Access Compliance Report Public Rights-of-Way (Curb Ramps)

Intersection ID: 29769 Main Street: BRAMBLE_CREEK_DR Cross Street: FAWN_HILL_RD Location: W

ADA ID: 8DA3DA894035 Ramp Type: PerpDiag Initial Pass/Fail: Fail Overall Compliance: No Severity Score: 8.75

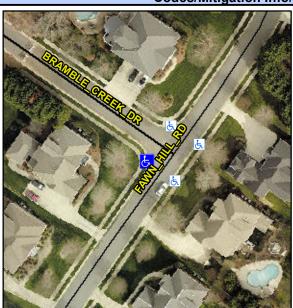
PROW/ADA:
Not Found, R304.5.1

Compl	iance Description	Data	Compl	iance	Description	Data
N/A	Ramp Length (in)	46.0	Yes	Ramp	Slope (%)	7.3
No	Ramp Width (in)	44.5	Yes	Ramp	XSlope (%)	1.0
N/A	Flare Type LT	N/A	N/A	Flare	Type RT	N/A
N/A	Flare Slope LT (%)	N/A	N/A	Flare	Slope RT (%)	N/A
N/A	Flare Traversable LT?	N/A	N/A	Flare	Traversable RT?	N/A
N/A	Landing Length (in)	N/A	N/A	DWS	Provided?	N/A
N/A	Landing Width (in)	N/A	N/A	DWS	Contrast?	N/A
N/A	Landing Slope (%)	N/A	N/A	DWS	Length (in)	N/A
N/A	Landing X Slope (%)	N/A	N/A	DWS	Full Width?	N/A
N/A	Landing Curb? (Y/N)	N/A	N/A	DWS	Offset (in)	N/A
N/A	Shared Landing?	N/A				
N/A	Gutter Ponding?	N/A	N/A	Gutte	r Slope (%)	N/A
N/A	Gutter Lip Ht (in)	N/A	N/A	Gutte	r X Slope (%)	N/A
N/A	Painted X Walk1?	No	N/A	Painte	ed X Walk2?	No
	X Walk 1 Direction	To SE		X Wal	k 2 Direction	To NE
N/A	X Walk 1 Width (in)	N/A	N/A	X Wal	k 2 Width (in)	N/A
	X Walk 1 Slope (%)	1.9		X Wal	k 2 Slope (%)	2.2
	X Walk 1 X Slope (%)	2.5		X Wal	k 2 X Slope (%)	1.9

Remove & Replace Curb Ramp With
Two New Directional Ramps or
Equivalent.
